### **HEARINGS OFFICER HEARING - LAND USE: THORNBURGH SITE PLAN**

**PROPOSAL:** Site Plan review for 70 Overnight Lodging Units (OLUs) in the Thornburgh Destination Resort.

- FILE NUMBER:** 247-21-001111-SP
- OWNER/APPLICANT:** Central Land & Cattle Co., LLC – Kameron DeLashmutt
- PROPOSAL:** Site Plan review for 70 Overnight Lodging Units (OLUs) in the Thornburgh Destination Resort.
- PROPOSAL LOCATION:** 67205 CLINE FALLS RD, REDMOND, OR 97756 / 67555 CLINE FALLS RD, REDMOND, OR 97756 / 67545 CLINE FALLS RD, REDMOND, OR 97756  
Map and Taxlots: 1512000007700 / 1512000007800 / 1512000007900
- HEARING DATE:** Wednesday, April 6, 2022
- HEARING START:** 6:00 pm
- STAFF PLANNER:** Caroline House, Senior Planner  
[Caroline.House@deschutes.org](mailto:Caroline.House@deschutes.org) / 541-388-6667
- RECORD:** Record items can also be viewed and downloaded from:  
<https://www.deschutes.org/cd/page/247-21-001111-sp-thornburgh-destination-resort-70-overnight-lodging-units>

*Figure 7 – FMP Master Development Plan Visitor Lodging Location  
(Reference Orange Areas inside Bubbled Area)*

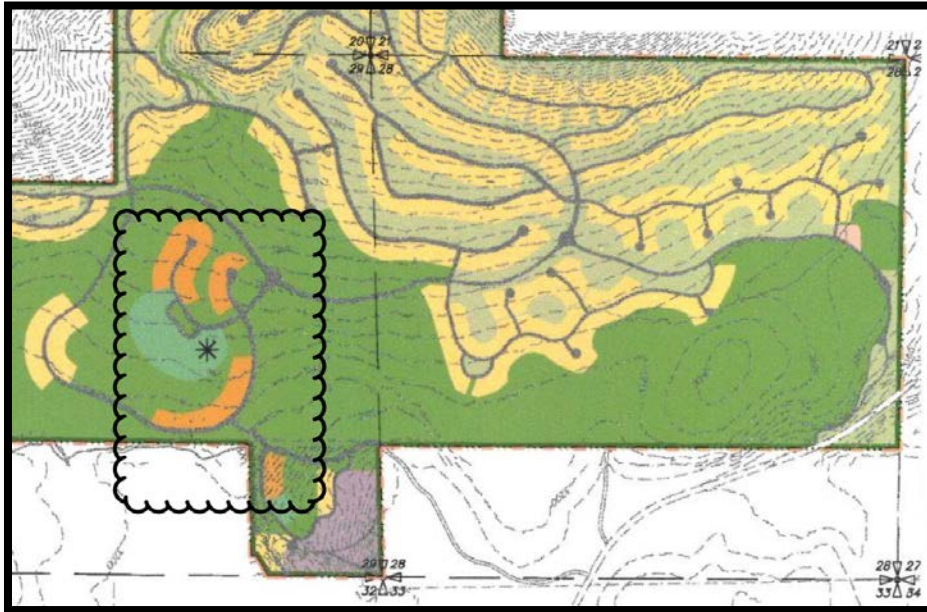
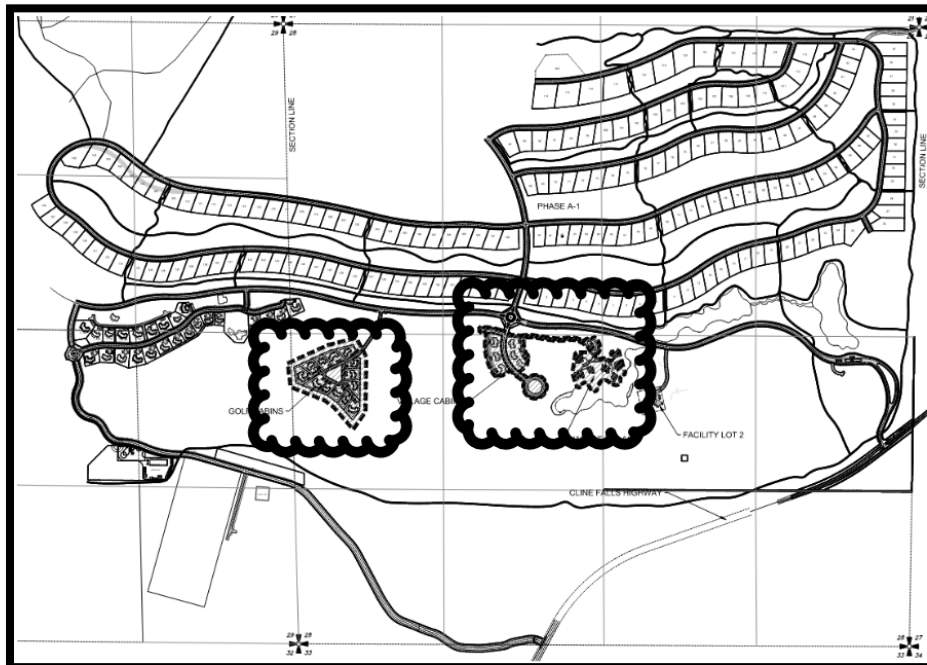
Based on this response, staff understands the applicant's current proposal is limited to site plan

approval for 70 OLUs in the general location allowed by the FMP Master Development Plan with no proposed changes to the FMP. As shown in *Figure 7* below, the FMP Master Development Plan identifies the general location of the required visitor lodging. The approved visitor lodging is located in Section 29 of Township 15S, Region 12E. However, the proposed OLUs will be located in Section 28 of Township 15S, Region 12E (see *Figure 8* below). For this reason, staff asks the Hearings Officer to determine if the proposed location complies with the FMP Condition 1.

*Figure 9 - Proposed Parking Location for Nature Villa OLUs*

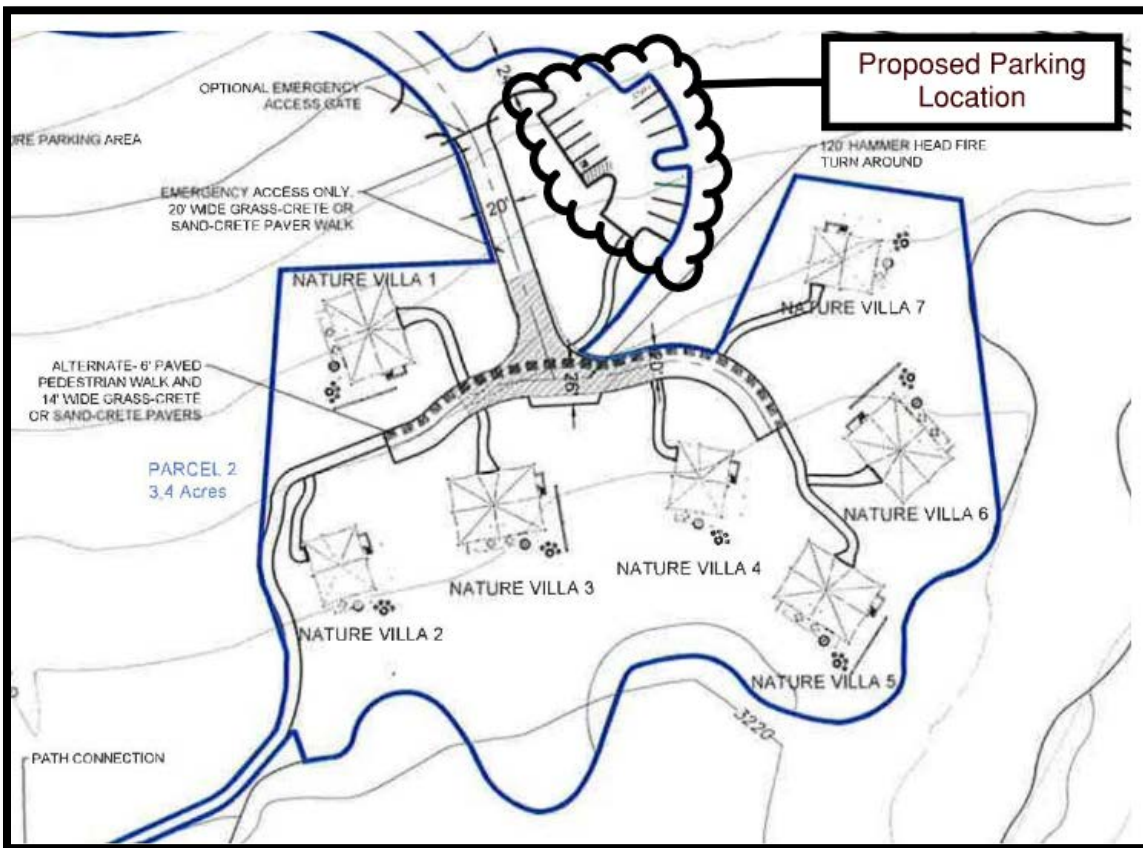
Staff finds the proposed parking spaces for the Nature Villa OLUs are not adjacent to each OLU structure (see *Figure 9* below). The Applicant's incomplete letter response, dated March 1, 2022, appears to acknowledge this discrepancy with the following response:

Staff asks the Hearings Officer to make specific findings on whether all of the requirements of FMP Condition 33 are met.

*Figure 10 – FMP Open Space Plan (Exhibit A.1.1)*

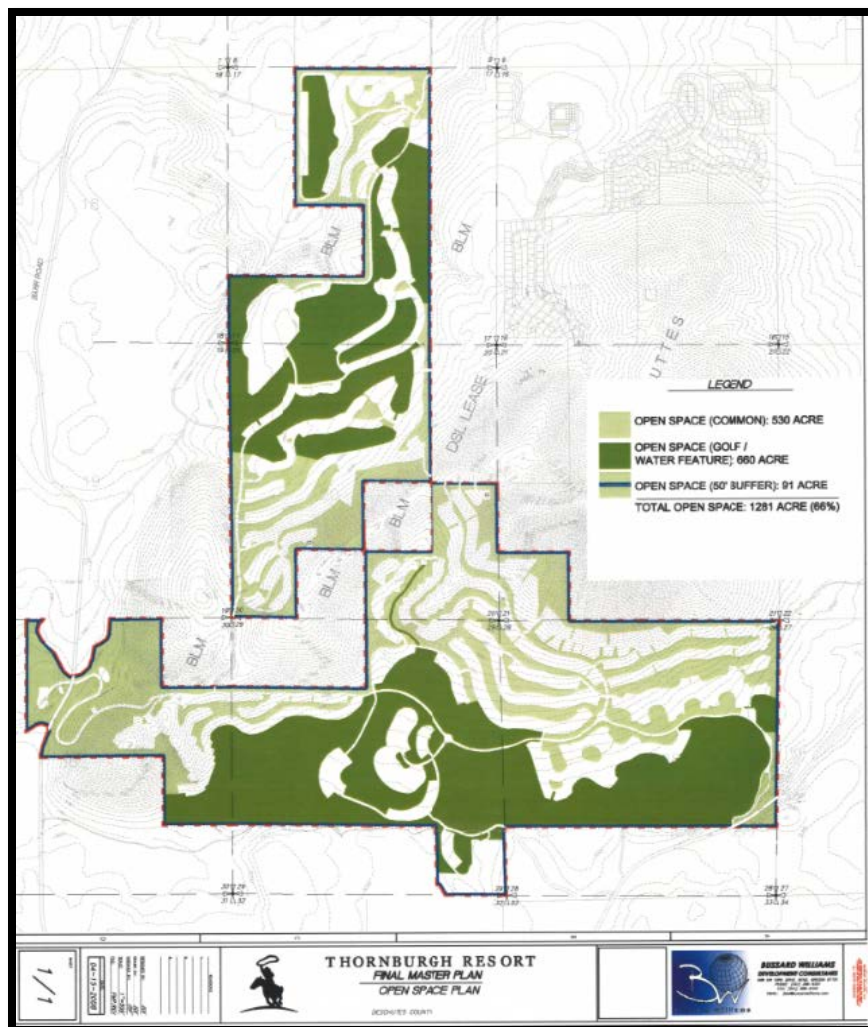
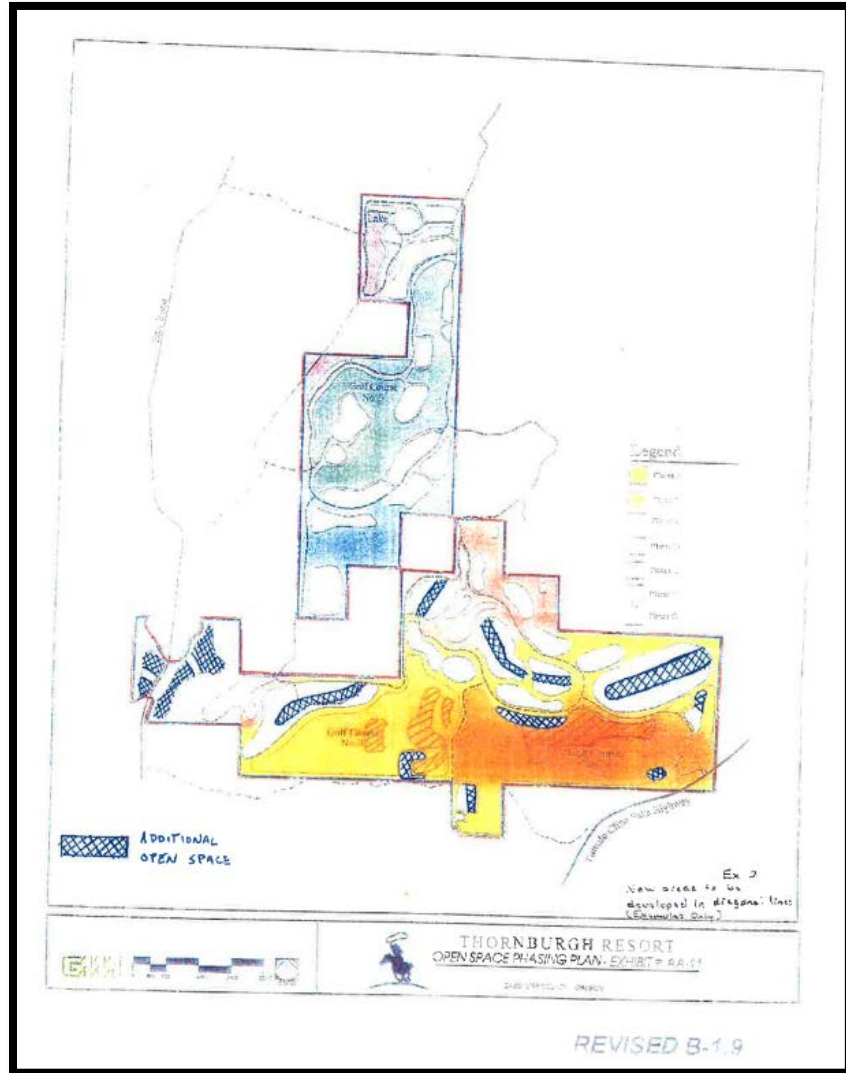
Figure 10 and Figure 11 below show the open space areas approved as part of the FMP. The proposed OLU site plans appear to be located in areas identified as open space areas on these maps. Staff recommends a condition of approval to ensure compliance.

Open Space Area Restoration. Where construction disturbs native vegetation in open space areas that are to be retained in substantially natural condition, Applicant shall restore the native vegetation. This requirement shall not apply to land that is improved for recreational uses, such as golf courses, hiking or nature trails or equestrian or bicycle paths.

Figure 14 -Village Cabin Overflow Parking Spaces

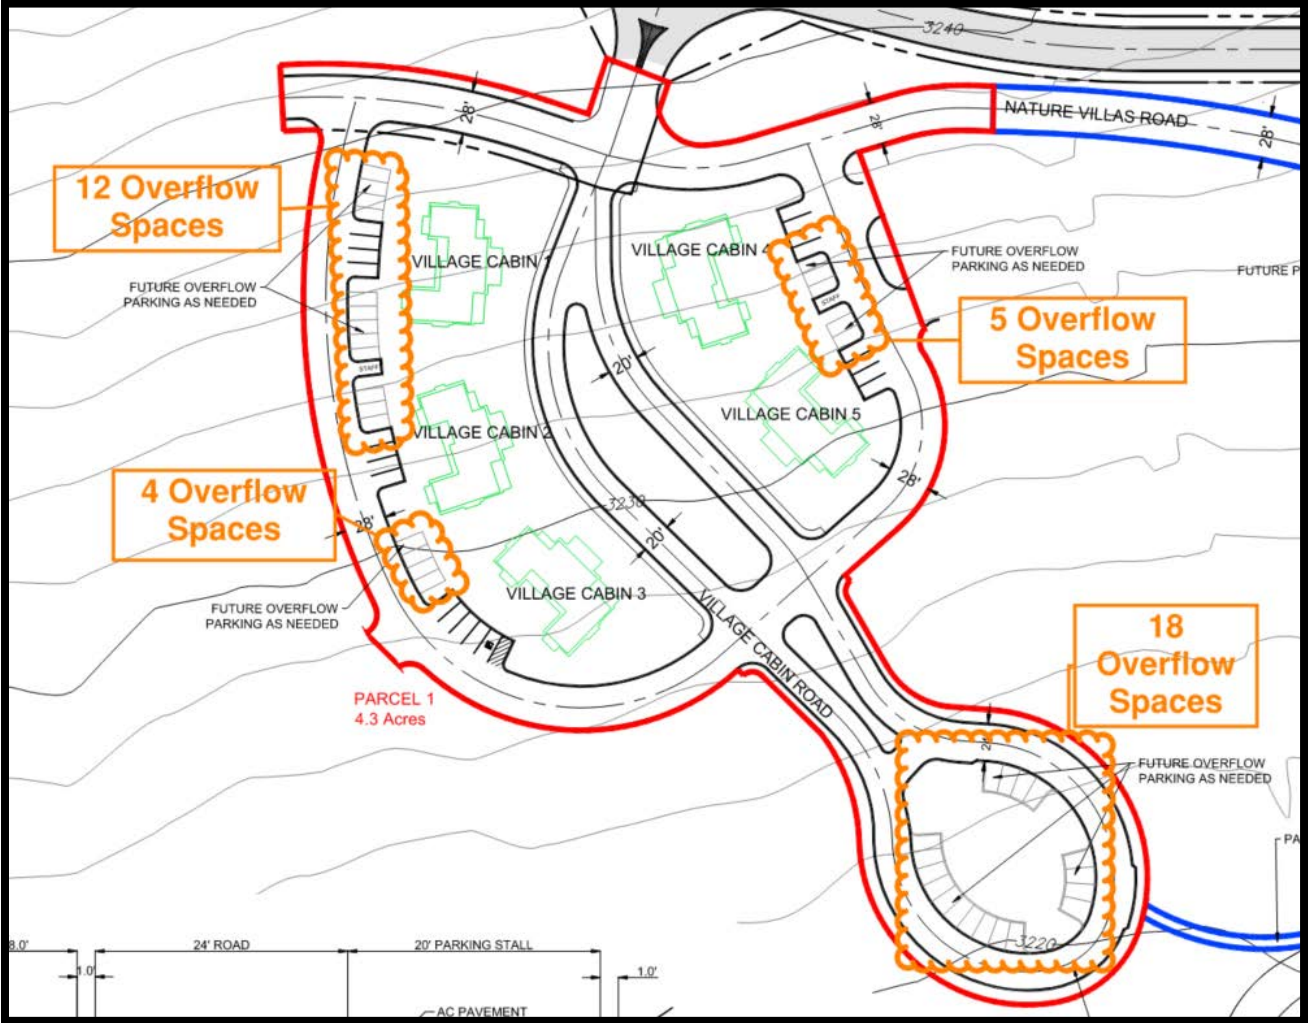
In addition to the required parking, it appears the applicant may be requesting approval for several

overflow parking areas for the Village Cabin OLUs use. The submitted site plan shows a total of 39 overflow parking spaces (see Figure 14 below). Staff notes no explanation was provided by the Applicant regarding why this amount of overflow parking is necessary for the Village Cabin OLUs, but not the other proposed OLUs. For this reason, it is unclear if these parking spaces are intended to be used in association with other, future, uses of the resort. Staff asks the Hearings Officer to make specific findings on what parking spaces are included in this review.

*Figure 15 - Distance of Southern Overflow Parking from Closest OLUs*

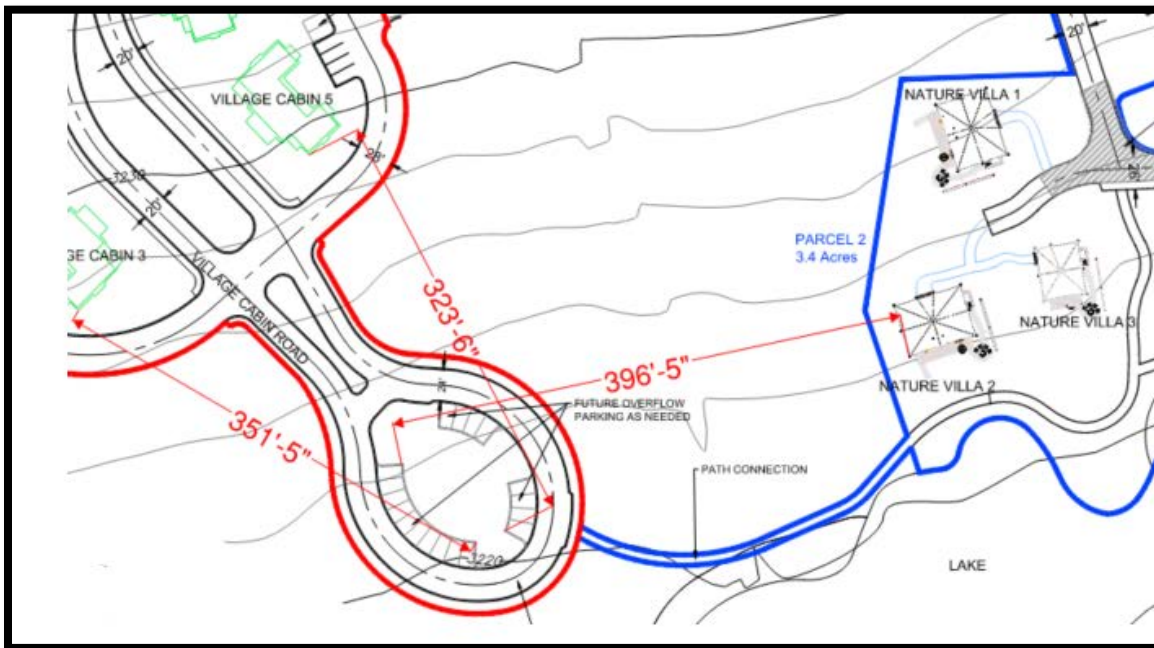
Based on this response, it appears the Applicant plans to submit future Site Plan review applications for other facilities located in the Village Cabin area. Based on this response, staff finds no joint use parking is proposed at this time.

*Figure 17 – Nature Villa Single OLU Bicycle Parking Location*

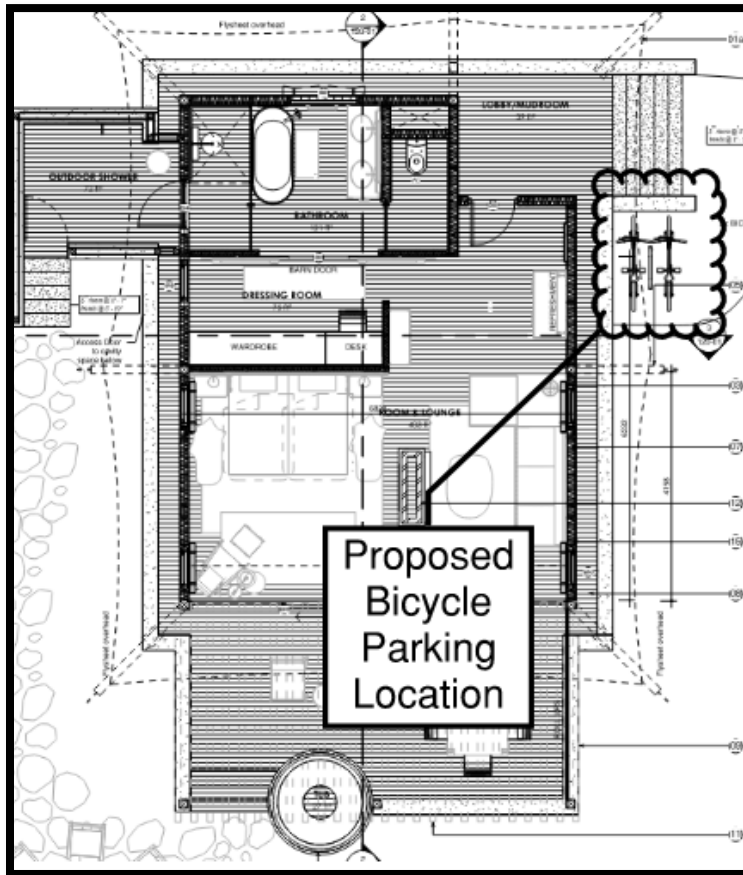
**FINDING:** Staff finds the proposed sheltered bicycle parking shown on sheets BP-11 and BP-13 do not comply with these criteria (see Figure 17 and Figure 17 below). The reference drawings shows this parking is only partially under a “decorative PVC flysheet”. Additionally, staff finds the proposed sheltered bicycle parking shown on sheets BP-1 and BP-9 are not fully covered. Staff asks the Hearings Officer to verify if the proposed bicycle parking complies with these criteria.

Figure 19 - Phase A-1 Tentative Plan Drawing

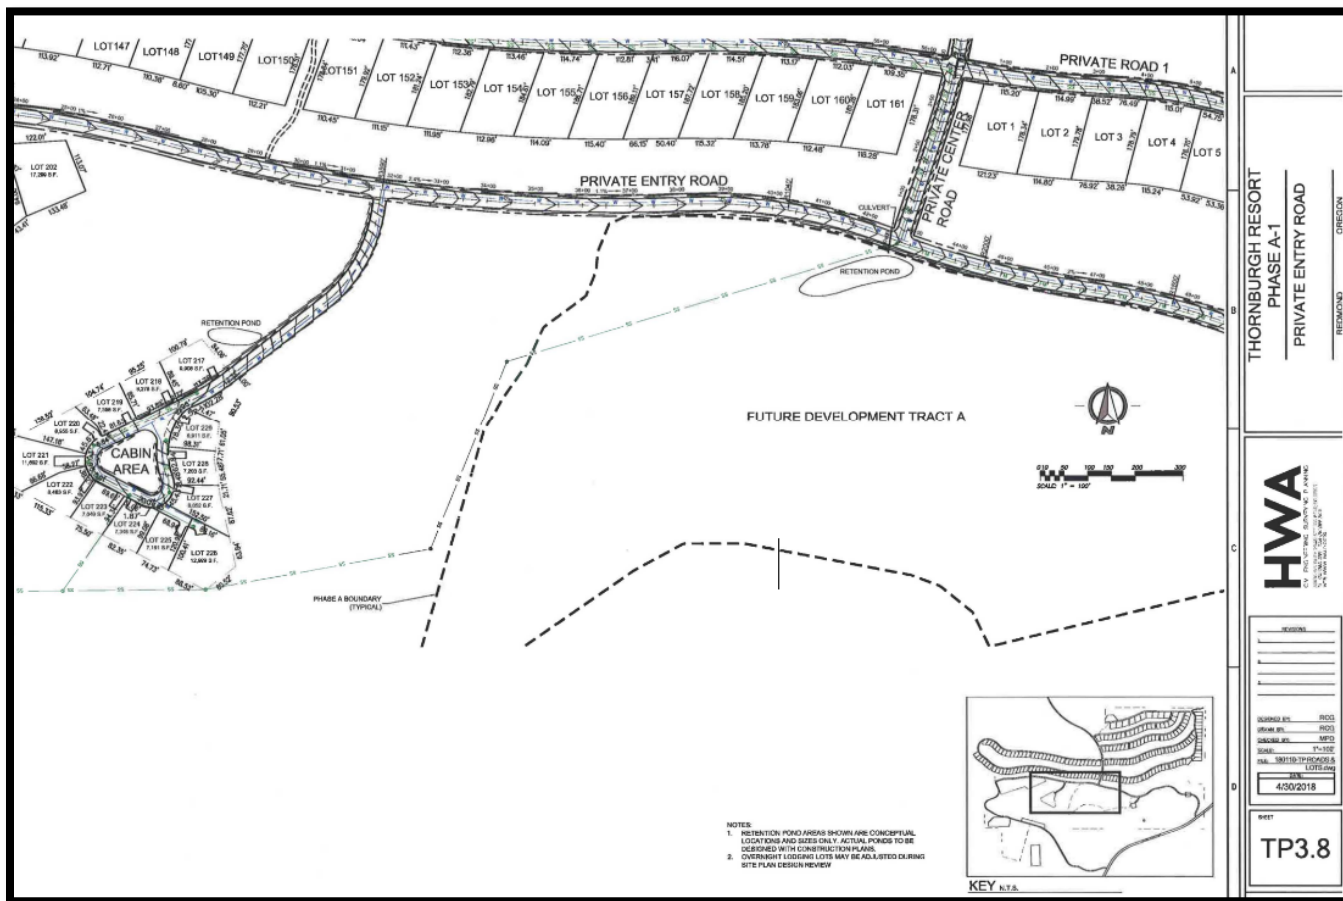
Staff finds only the access point and street layout for the proposed Golf Course Cabin OLU's was evaluated under the Phase A-1 Tentative Plan approval. As shown in Figure 19 below, the proposed development area for the Village Cabin OLU's and Nature Villa OLU's is identified as a "Future Development Tract A" and this figure clearly shows this area is not located within the "Phase A Boundary".

Staff finds the proposed roads and alleys shown on the Village Cabin OLU's and Nature Villa OLU's have not been reviewed as part of a Tentative Plat approval. Therefore, it is unclear to staff if the proposed roads and alley meet all of the applicable design requirements of DCC Title 17. Additionally, it does not appear the proposed alley access to Golf Cabin Lots 224-227 has been approved by the County.

The Applicant's proposal shows Village Cabin Road will extend more than 300 feet beyond the location of the proposed OLU's. Staff finds this proposed street segment is not necessary to serve the proposed OLU's and will disturb additional native vegetation on the site. Staff notes Sheet C6.0 shows the proposed road network adjacent to the proposed Village Cabin OLU's has the necessary

Figure 20 – Phase A-2 Tentative Plan Drawing

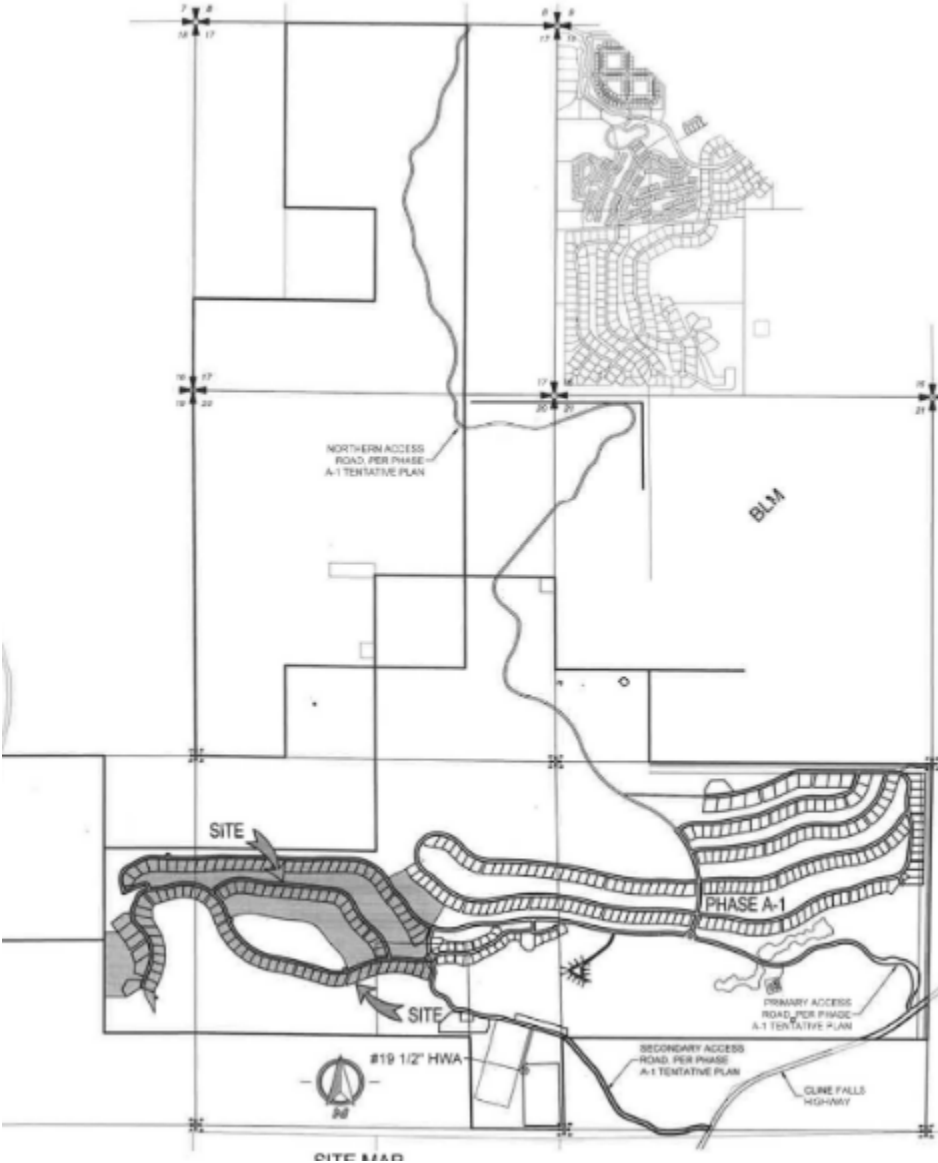
Staff finds the roads serving the Golf Cabins OLUs were reviewed under Tentative Plan A-1. However, the A-2 Tentative Plan approval did not include any areas within the proposed OLU development areas and the relevance of this review, as part of the current proposal, is unclear (see Figure 20 below). Staff finds the proposed Village Cabin Road and Nature Villas Road have not been

reviewed as part of a Tentative Plan approval and do not appear to be laid out as shown on the FMP Master Development Plan. For these reasons, staff believes the applicant has not obtained the necessary approvals from the County to establish these roads as the County has not been afforded an opportunity to review and identify required sight distance, turn and acceleration/deceleration lanes, right-of-way, roadway surfacing and widening, or bicycle and pedestrian connections. Staff asks the Hearings Officer to make specific findings on this issue.
